Circulation - All Rolls-Royce  
Franchise Holders

DELETION OF RIDE CONTROL

All Rolls-Royce Silver Cloud III cars and all Bentley S3 cars.

FIG. 1 EARLIER ASSEMBLY

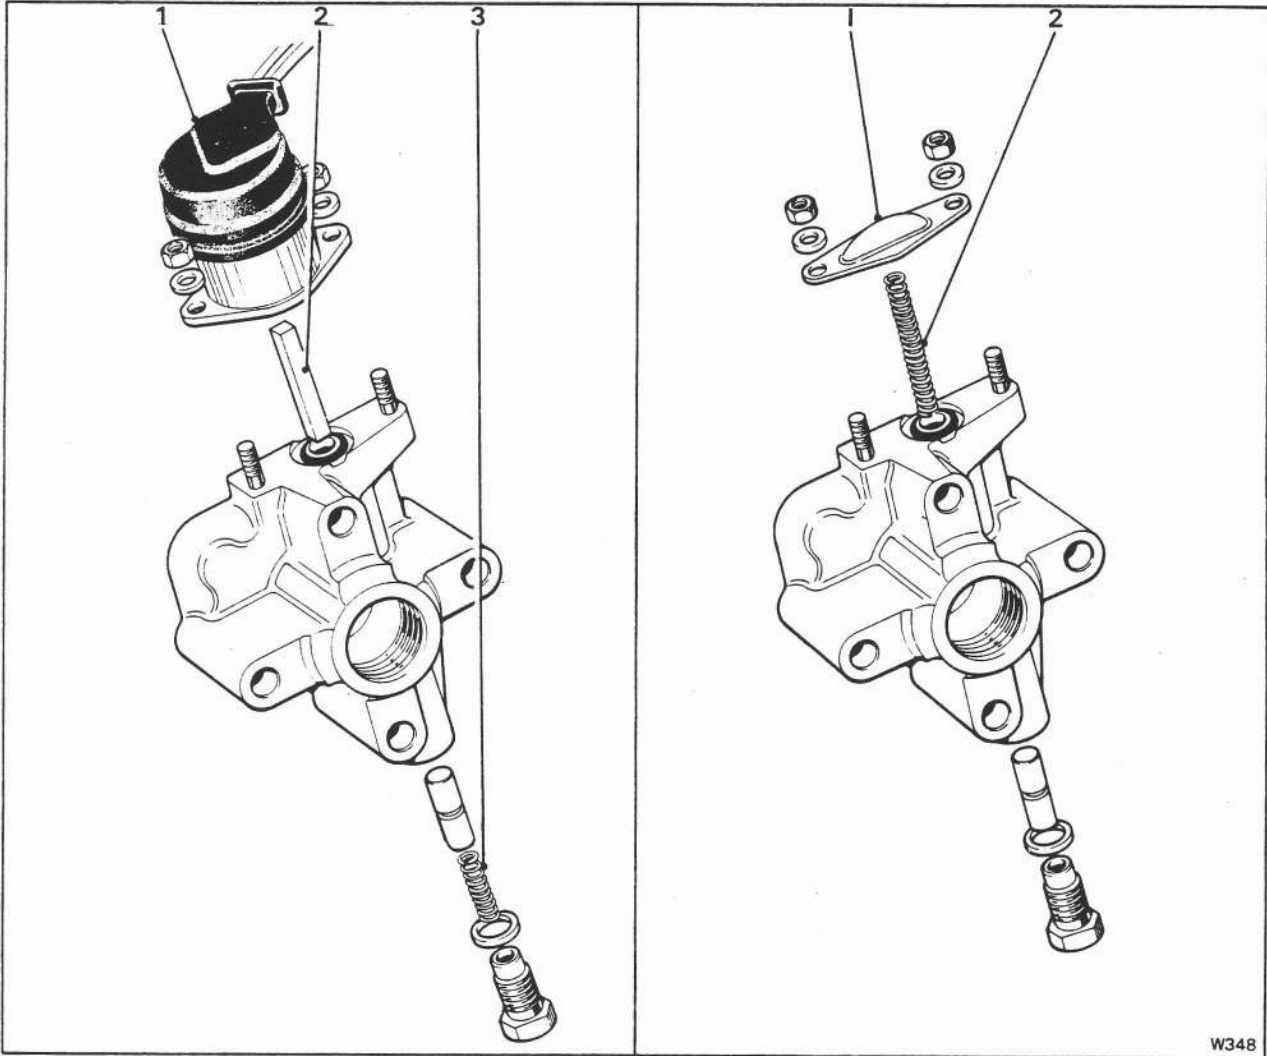
The rear damper solenoid, slow leak push rod and spring, have been discontinued. A new spring is fitted in place of the push rod and a blanking plate is fitted in place of the solenoid.

- 3 Disconnect both the wires to each rear damper solenoid and tape them back into the loom.
- 4 Remove the ride control solenoid (see Fig 1)
- 5 Remove the solenoid spring (see Fig 1)
- 6 Remove the slow leak push rod (see Fig 1)
- 7 Fit the new spring in place of the slow leak push rod (see Fig. 2)
- 8 Fit the blanking plate in place of the solenoid (see Fig. 2)

FIG. 2 LATER ASSEMBLY

- 1 Blanking Plate
- 2 Spring
